Technical Service Bulletin

96 Rattle/clunk from front of vehicle while driving

96 13 58 2033812/1 May 7, 2013.

Model(s)	Year	VIN Range	Vehicle-Specific Equipment
A6/A7	2012-2014	All	Homelink

Figure 1. Homelink control module tab not secure.

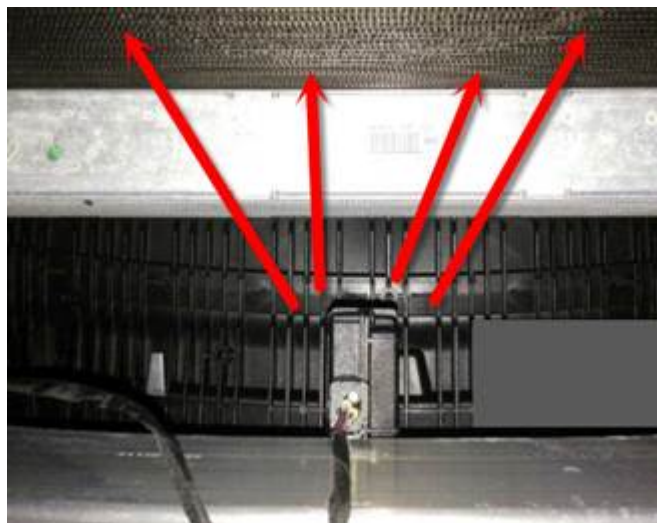
The locking tab for the Homelink control module does not securely hold the module in place (Figure 1), which causes it to come loose and bang against various support structures at the front of the vehicle (Figure 2).

Figure 3. Retaining clip with highlighted section to be removed.

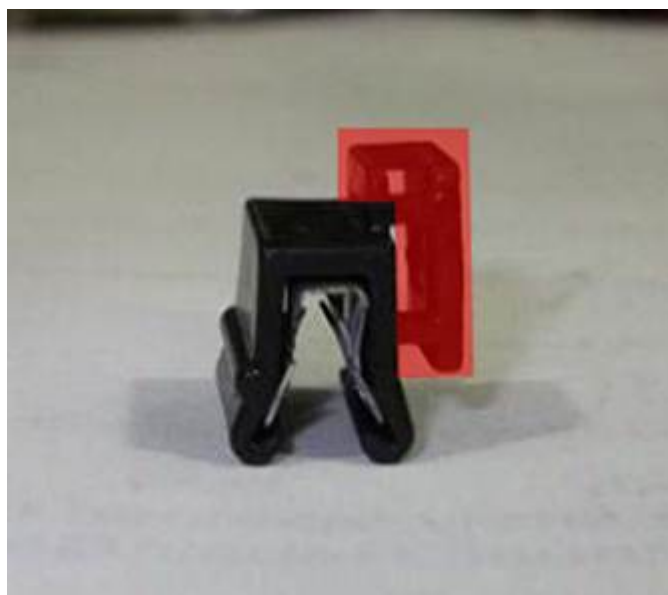
1. Reinstall the Homelink control module into factory location.
2. Using clip **3D0971838E**, trim extra support bracket highlighted in red as shown in the illustration at right (Figure 3).

3. Install the modified clip behind the locking tab to secure it in place (Figure 4).
